febi 32682

to fit:

Water pump

NEW - febi 32682

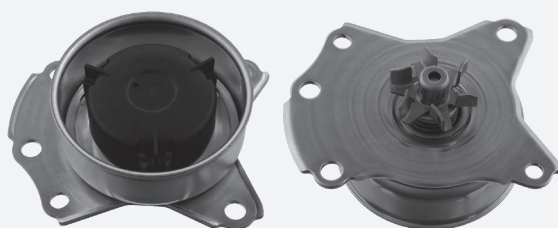
The water pump leaks.

The water pump fitted by the vehicle manufacturer can leak, because the material used is perforated steel sheet. In the worst case, this can lead to significant engine damage.

febi recommends using water pump febi no. 32682. This modified version of the water pump is manufactured from aluminium die casting. This makes the pump significantly stronger, and prevents leakage. Additionally, febi supplies water pump 32682 including the required gasket and suitable bolt set.

When fitting the new version febi 32682, please use bolts supplied with water pump. Torque setting for bolts is 28nM. The vehicle manufacturer's specifications should always be followed!
